# Agenda Item 5

PLANNING SUB-COMMITTEE

Thursday 5th September 2024

- ADDENDUM TO AGENDA –

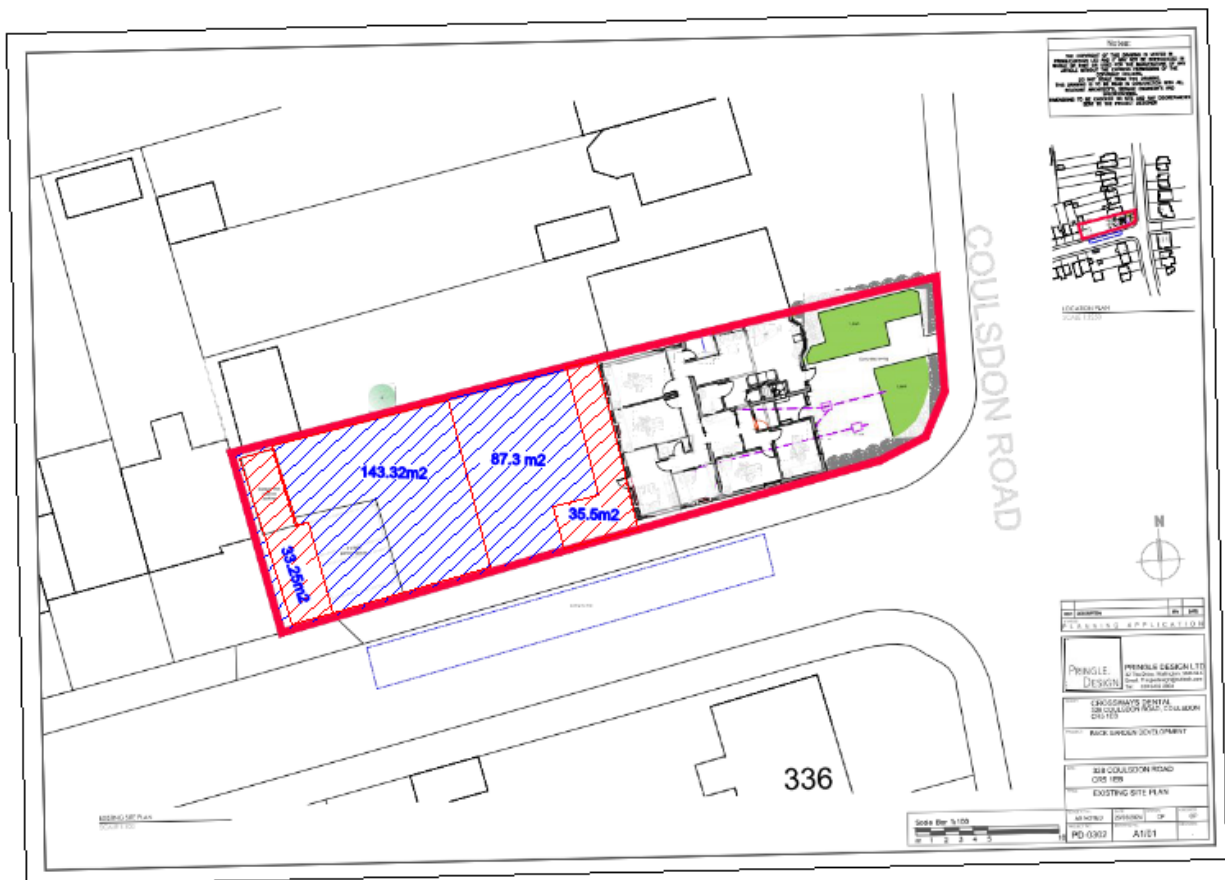
An additional representation has been received from a neighbour disputing the figures stated in paragraph 8.7 of the officer's report with regards to retained garden areas.

'The total area of the application site excluding the garage, and the hardstanding is 176.5m<sup>2</sup>. The hardstanding is just wider than the garage (see image 3) and runs from the street pavement to the garage itself. The area for the hardstanding and the garage is 33.2m<sup>2</sup>, which leaves 143.3m<sup>2</sup> remaining. I have not included the area identified as 2 x Staff parking spaces (shown larger on the drawing) as this has not been mentioned in the report, only the hardstanding. The 240m<sup>2</sup> is based on the area including the area identified as staff car parking, but not the area abutting the dental surgery.

I would contend that the hardstanding abutting to the dental surgery should also be taken into consideration in the calculation. If accepted, then the space would be reduced to 87.3m<sup>2</sup>. If not, and the area remains as per the report as being 122m<sup>2</sup>, it is still below the 50% threshold and therefore not in accordance with policy DM10.4e.'

The garden division has been calculated as follows:

- Existing: 244.17sqm (not including the parking area as this is not amenity space).
- Proposed: 122.81sqm = half of the existing garden area retained (policy compliant).
- The hardstanding and shed directly behind the host building form part of the existing garden area so has not been removed from the calculation.
